## Thesis Changes Log

**Name of Candidate:** Rahim Samanbakhsh

**Title of Thesis:** Design of Power Converters for Renewable Energy Sources

**Figure 4.1** Switching pattern

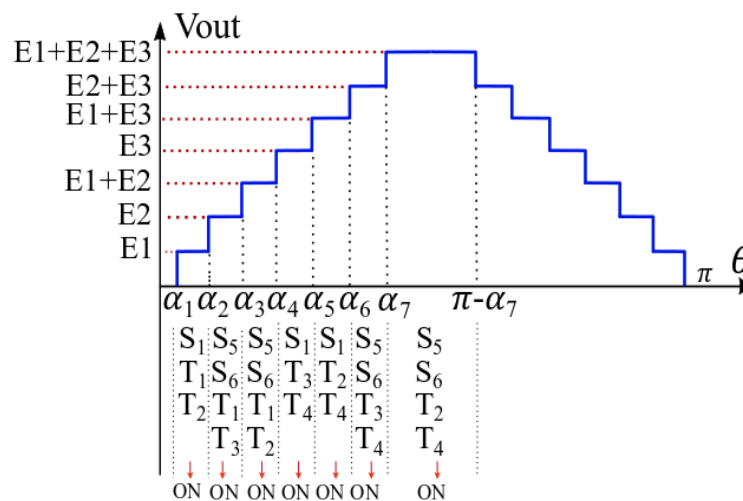
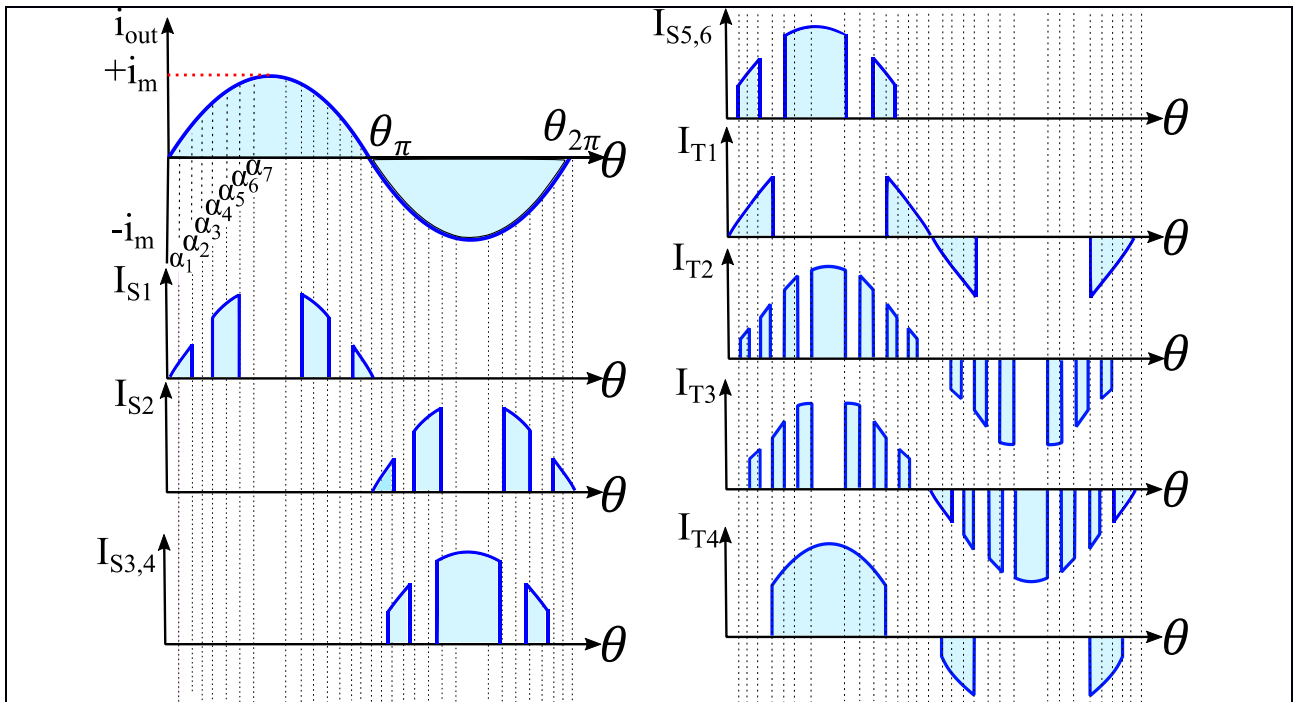
1. Specific need for 3 DC sources for the multilayer inverter: what would be the power distribution between them, and how this affects the harmonics?

**Response:** Thank you for your comment and questions.

To measure power distribution, needs to find duration of switching pattern. In below the figures shows the voltage and current for the proposed topology.

Now we have voltage and current of inputs, therefore can be calculate the power of each inputs:

According to Figures (4.1, and 4.3), the area of current and voltage are not the same for each input, therefore can be concluded that the power distributions are not symmetric. However, as the inputs are isolated, it does not have an effect on output voltage harmonics.
